# SAN FRANCISCO PLANNING DEPARTMENT

## Discretionary Review Full Analysis

*Date:* September 22, 2016  
*Case No.:* 2015-007313DRP-05VAR  
*Project Address:* 870-872 UNION STREET  
*Permit Applications:* 2015.11.13.2622 &  
2015.11.13.2623  
*Zoning:* RM-1 (Residential-Mixed, Low Density)  
40-X Height and Bulk District  
*Block/Lot:* 0100/020, 085-087  
*Project Sponsor:* Brian Milford  
Martinkovic Milford Architects  
101 Montgomery Street, Suite 650  
San Francisco, CA 94104  
*Staff Contact:* Nicholas Foster – (415) 575-9167  
[nicholas.foster@sfgov.org](mailto:nicholas.foster@sfgov.org)  
*Recommendation:* **Do not take DR and approve the project as proposed.**

Section 317B Calculations

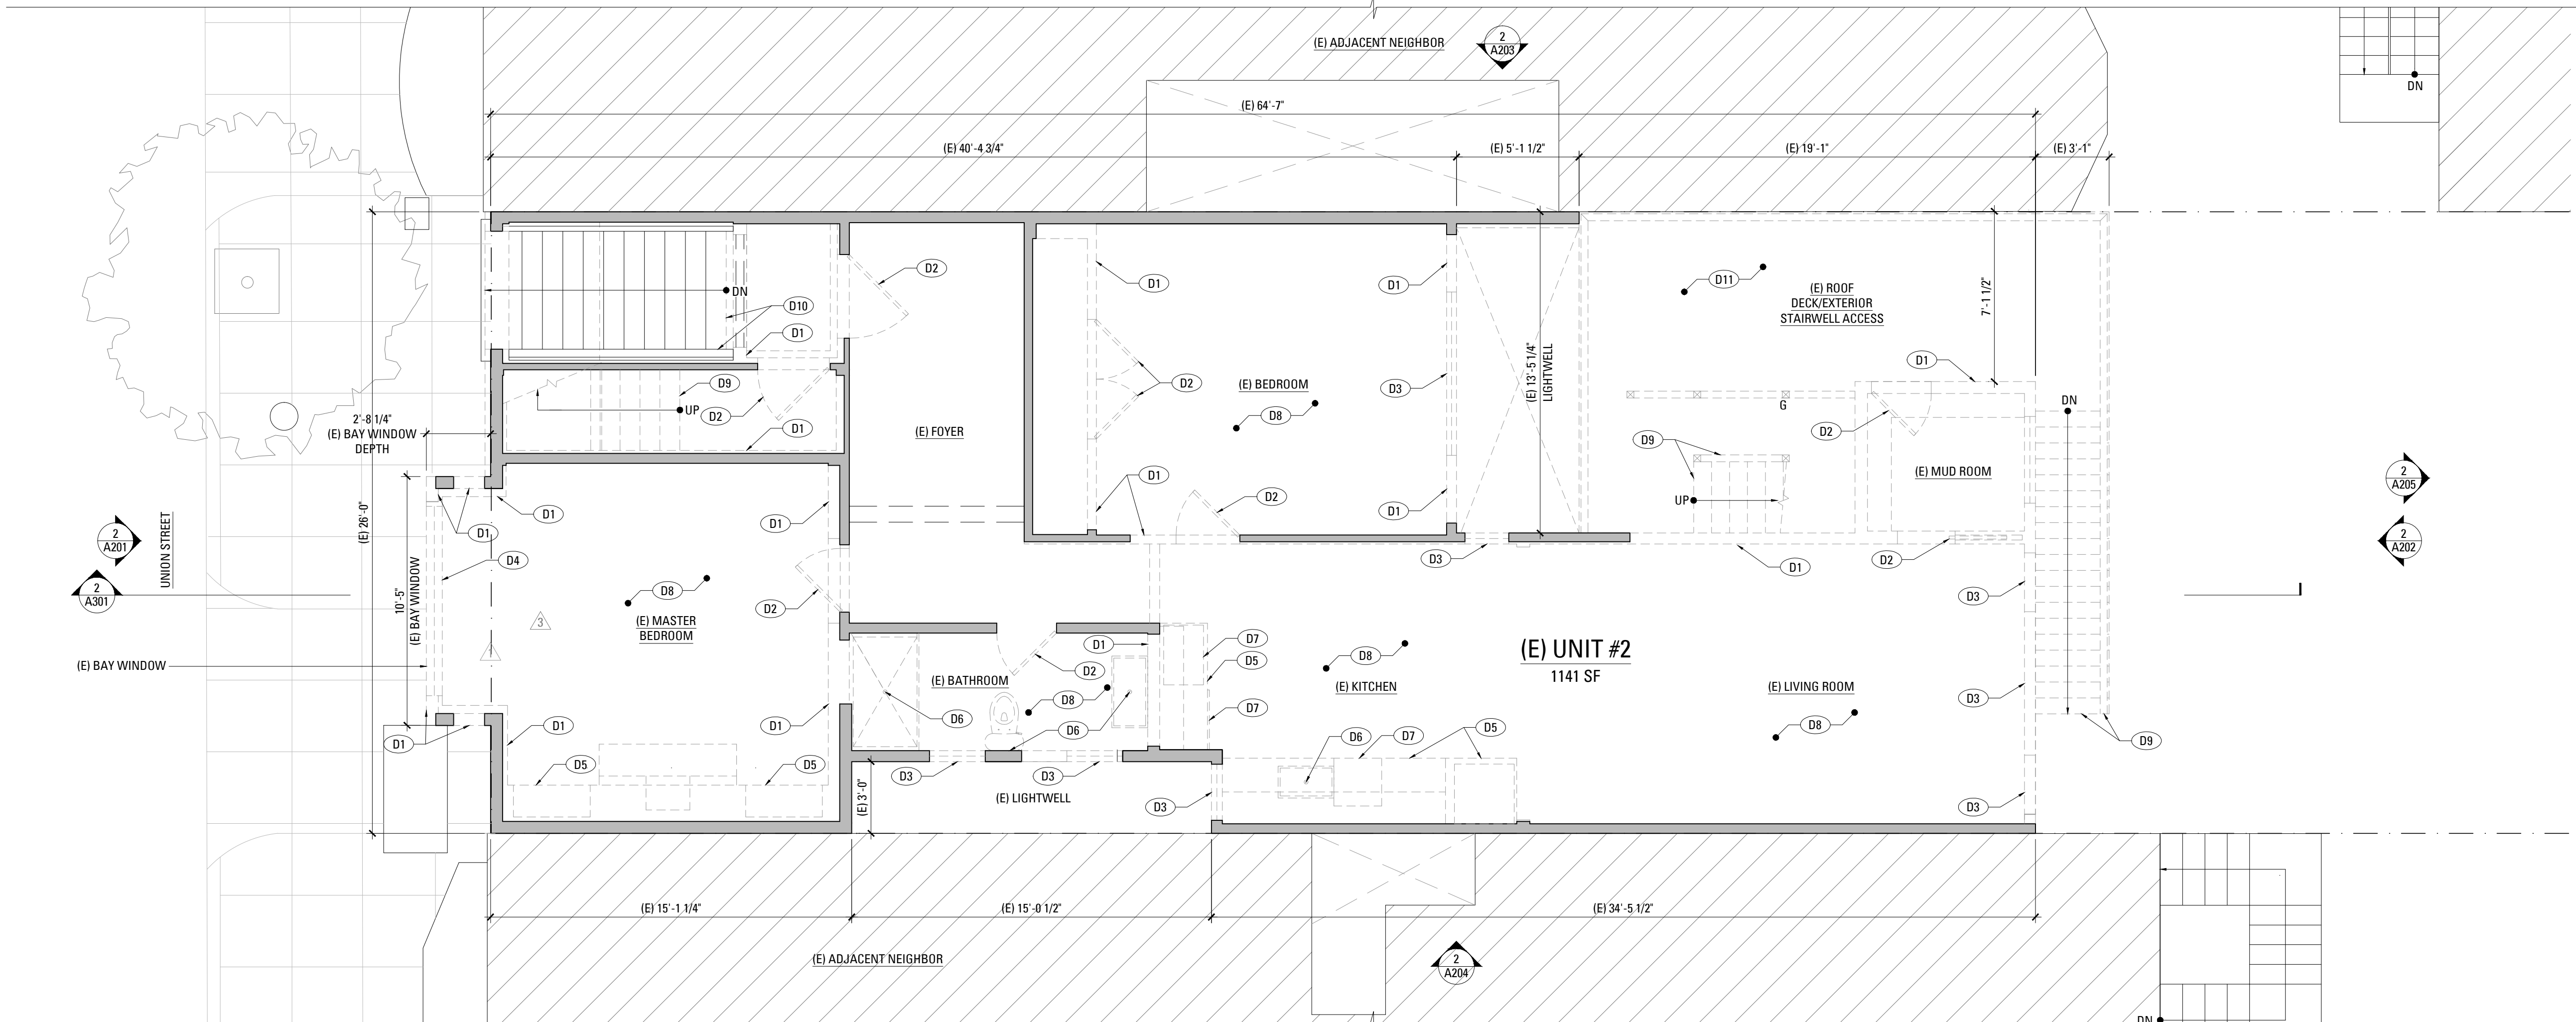
4.	A005	Please provide demolition calculation pursuant to Section 317.	See sheet A005 for the illustrated demolition calculations as derived from the required method described in Section 317.	MMA

A116

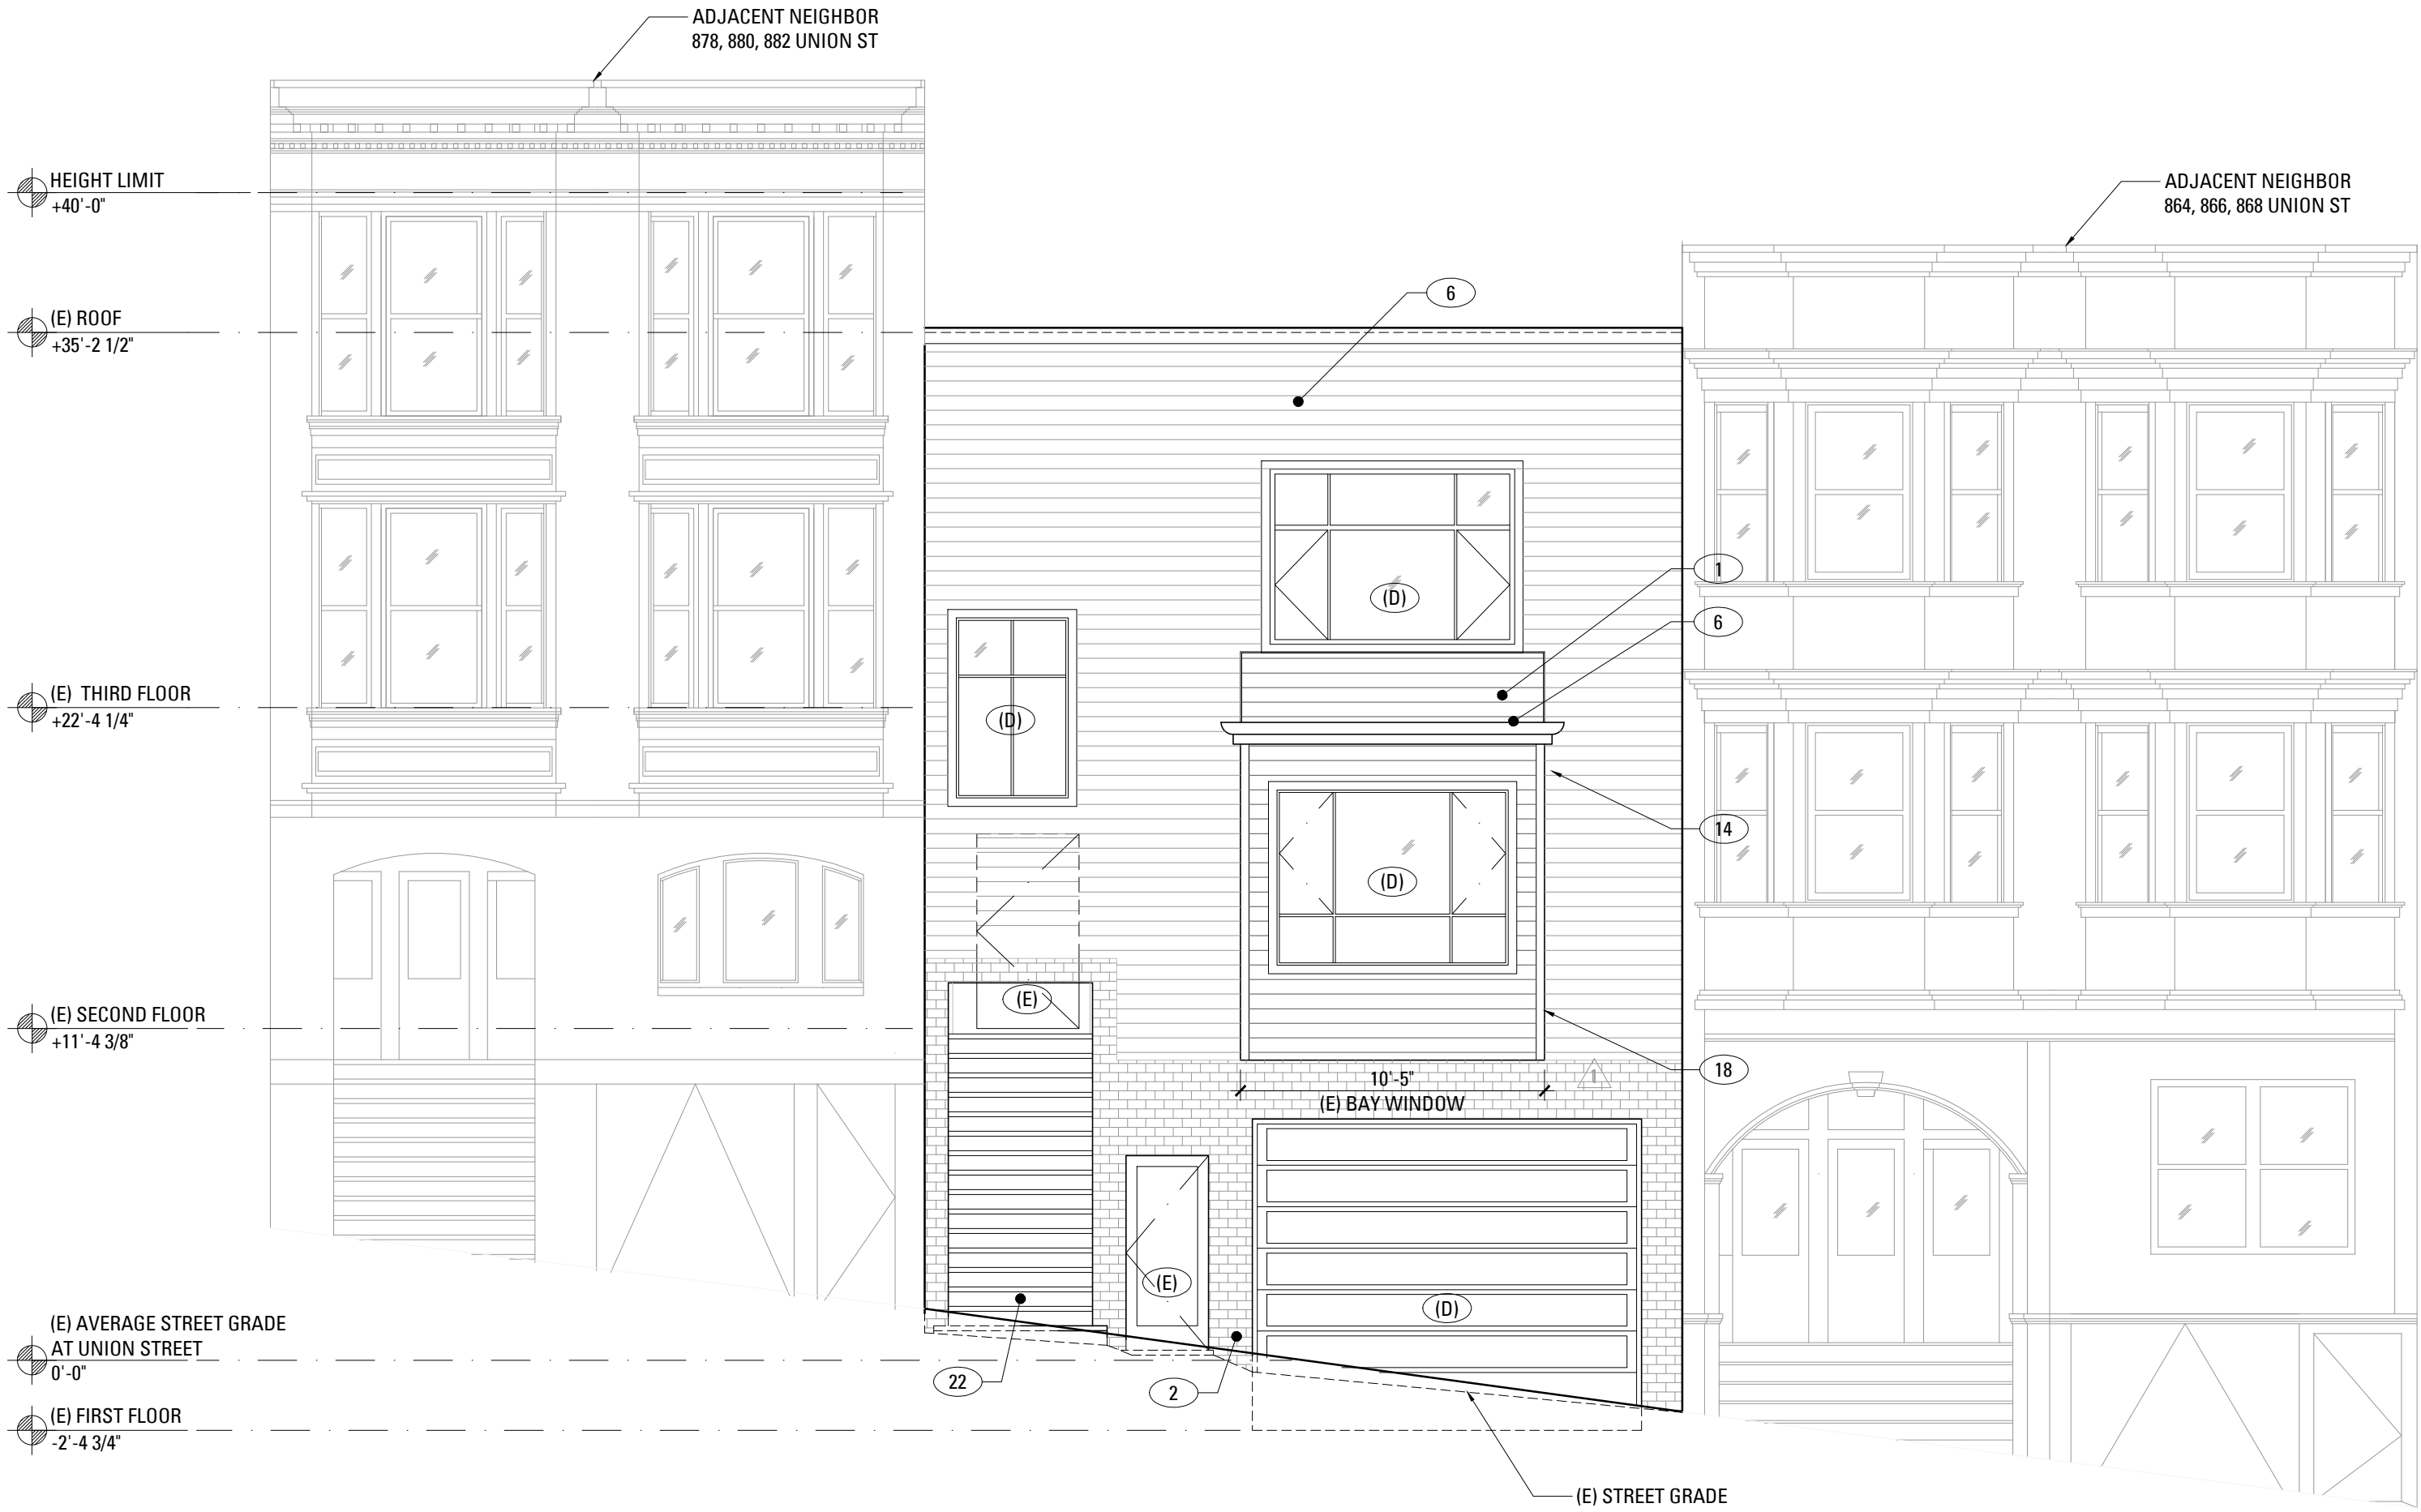
2.	A116 A206	The prevailing street wall on Aladdin Terrace is primarily 2 and 3-stories. Please setback the fourth floor to match upper story of existing neighbor to the east.	See sheet A206 and A116 for proposed setback at the upper story. The proposed new structure has been designed to be consistent with the existing buildings to either side of it. Both properties adjoining our proposed project are the same relative height as our proposal. The property located to the west, has no setback at the top story and the other property located to the east has a setback of approximately 15' from the front building wall. We are proposing to average the setbacks between the 2 adjacent structures with a setback approximately 7'-6" from the property line along Aladdin Terrace for the 4 <sup>th</sup> story only.	MMA

Residential Design Team Comments				
NO.	SHEET	COMMENT	RESPONSE	RESPONSE BY
<b>Aladdin Terrace Building</b>				
1.	A116 A206	Provide a 15 foot setback along Aladdin Terrace.	See sheet A206 and A116 for proposed 15' setback at the upper story along the Aladdin Terrace street frontage.	MMA
2.	A114	Limit the garage door width to 10 feet as required by Code, RDT does not support a request for a garage door width variance.	See sheet A114 for our proposed garage door width to be maximum 10' wide.	MMA

A201

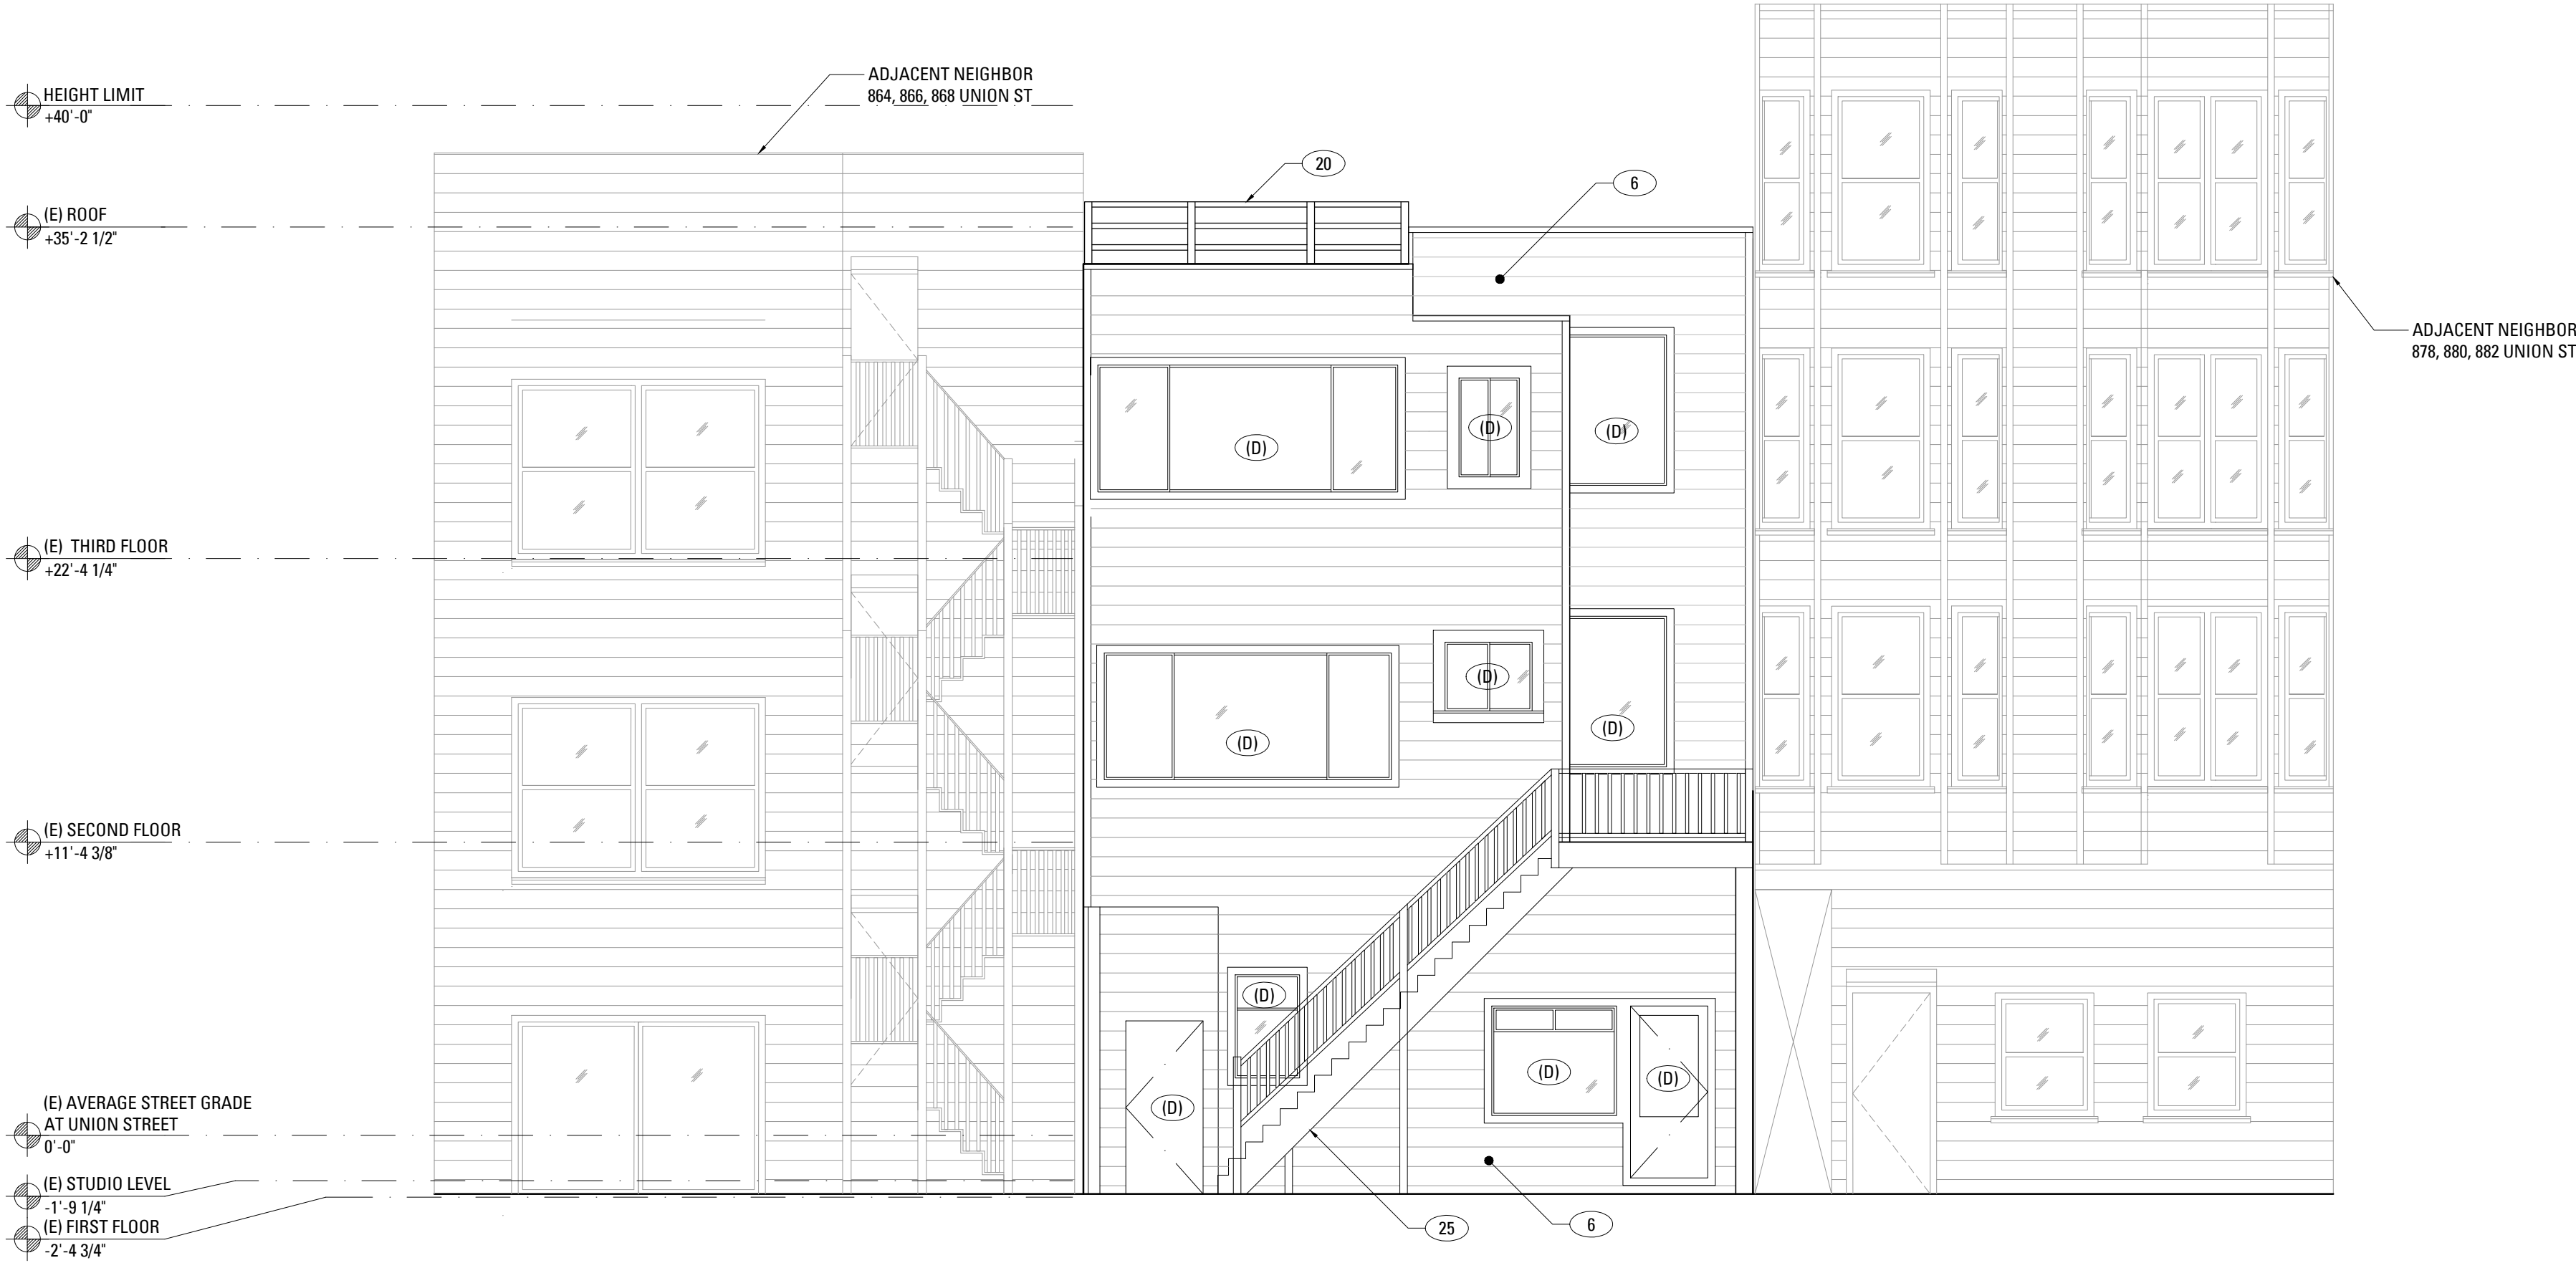
9.	A112 A201	Please consider extending the bay projection to upper floors.	See sheet A201 for the new proposed front façade. The existing bay window has now been extended to upper floors.	MMA

10.	A112 A201	RDT would support eliminating the upper setback and pulling the upper story to the front of the building face.	See sheet A112, A113, and A201 for the revised floor plans and front elevation to eliminate the front set back at top floor.	MMA
11.	A201 A301	Provide a strong roof cap/termination compatible with neighboring buildings.	See sheets A201 for the new proposed roof cap and termination to be more compatible with the neighboring buildings.	MMA
12.	A201	Improve the solid to glazing ratio and proportions compatible with context.	See sheet A201 for the revised front façade design proposal with proportions to be more in context with the neighboring buildings.	MMA
